Subject: Seismic Re-Evaluation of the NSSS Piping

Current SER Discussion

Detroit Edison Comments

SECONDARY CONTAINMENT RESPONSE
DUE TO A DBA-LOCA

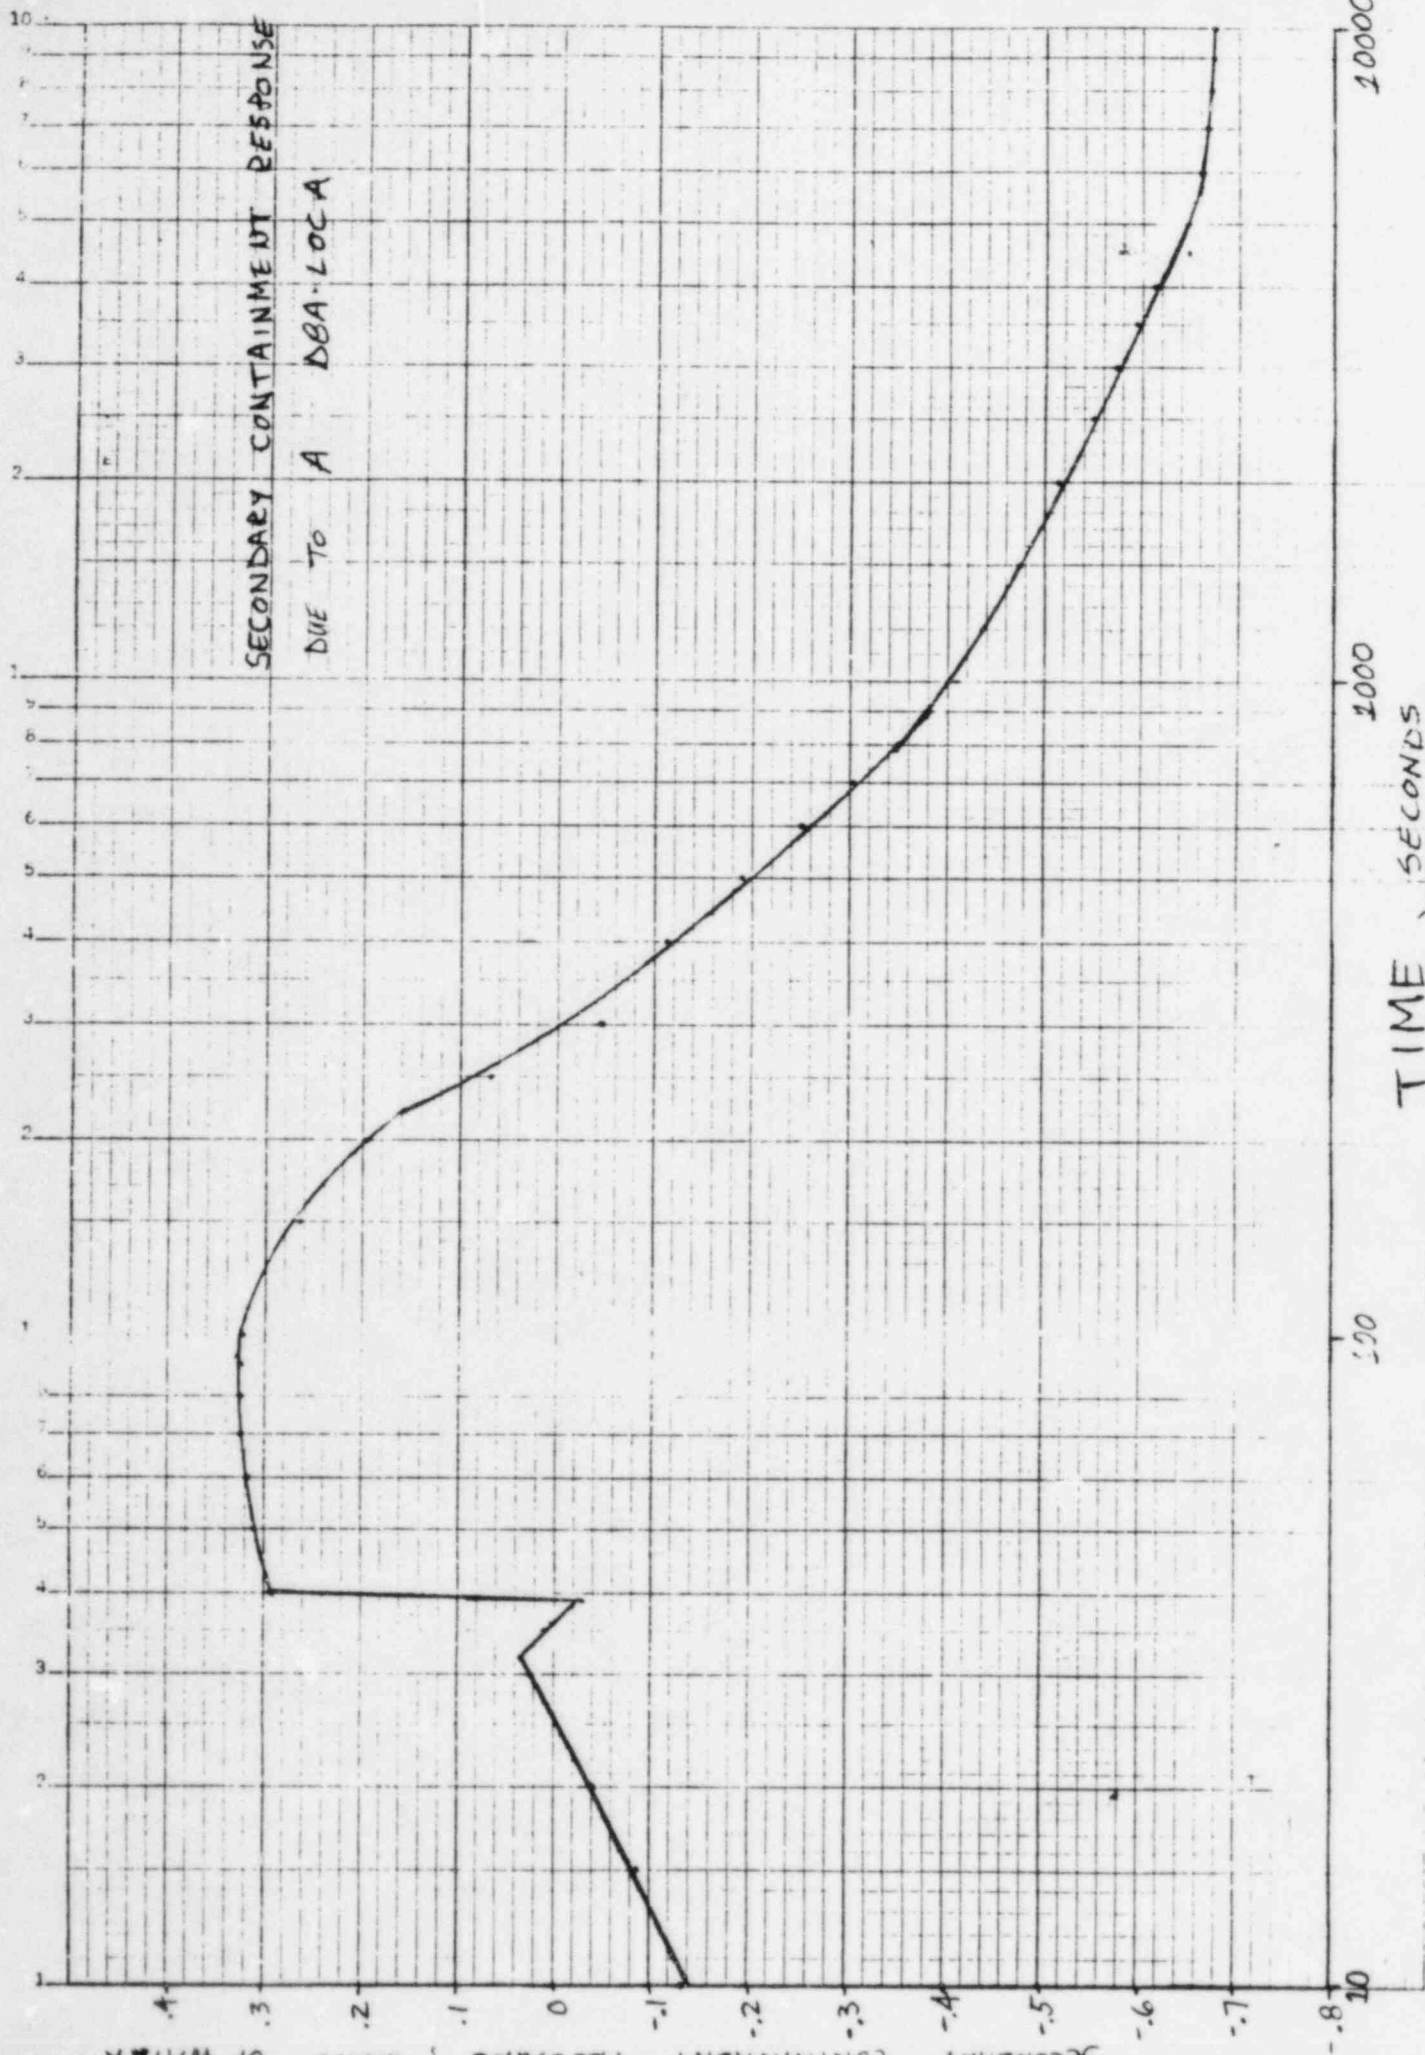
The secondary containment response due to a DBA-LOCA is shown in Figure 1. During the first 33 seconds, the pressure increases to a slightly positive value. With the activation of the SGTS at 33 seconds and the activation of the area coolers at 38 seconds, the pressure decreases to near atmospheric.

At 40 seconds, pressure relieving doors on the common wall between the torus room and the corner rooms open and allow heated torus room air to enter the rest of secondary containment. This step input of heat into the secondary containment appears as a sharp pressure spike on Figure 1.

The pressure then decreases past -0.25 inches of water to a steady state secondary containment pressure. A period of approximately 600 seconds elapses from the start of the DBA-LOCA event to the point where the secondary containment pressure decreases to and subsequently stays below -0.25 inches of water.

The Fermi 2 SER assumes a secondary containment drawdown time of six minutes (Section 6.2.3). A radiological consequence analysis using this time is discussed in SER Section 15.2.3.1. An extrapolation of this analysis was made to assess the effects of the increase in drawdown time. The post LOCA thyroid dose at the site boundary would be increased approximately thirty percent but would remain well within the guidelines of 10CFR100. This dose is based on very conservative assumptions.

The FSAR is being revised to reflect a maximum ten minute drawdown time to achieve minus one-quarter inch of water pressure in the secondary containment post LOCA. Your expedited review and concurrence is requested. Please coordinate a revision to the SER with our technical specification reviewer to support the proof and review process.
